Cottam Solar Project

Figure 8.16.10: Landscape and Ecology Mitigation and Enhancement Plan – Cottam 3A Revision A

PINS reference: EN010133
Document reference: EX1/C6.4.8.16.10_A
APFP Regulation 5(2)(a)

Schedule of Changes

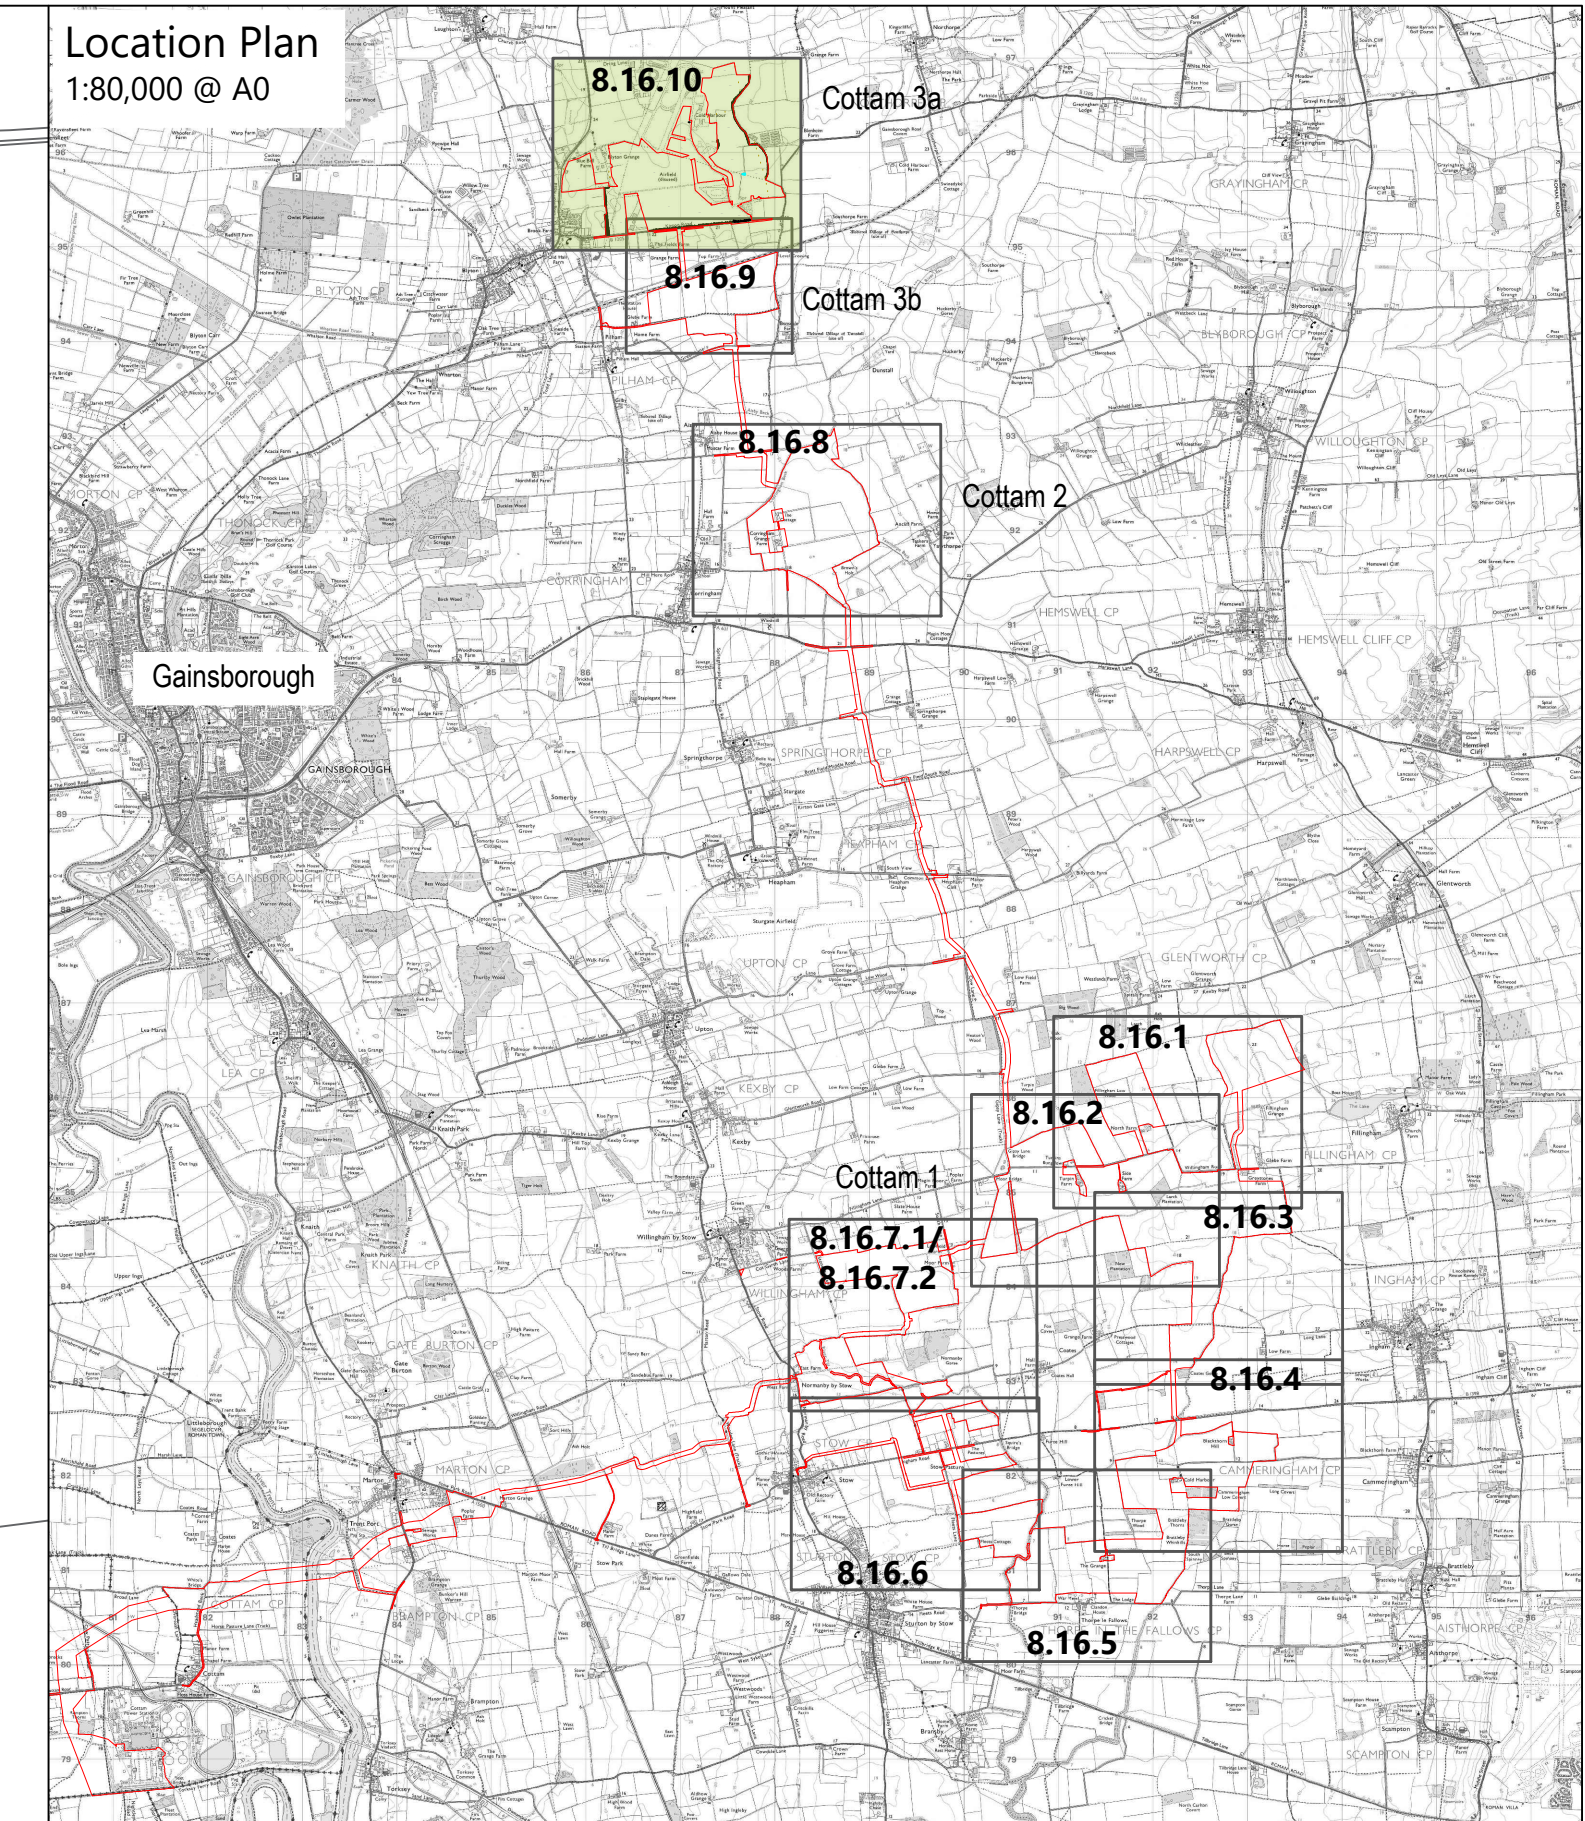
Figure Reference	Page	Description of Changes	Reason for Revision
Figure 8.16.10	3	Change to spelling of 'enhancement'. Offset calculations from drains.	For clarity and to correct a typo.
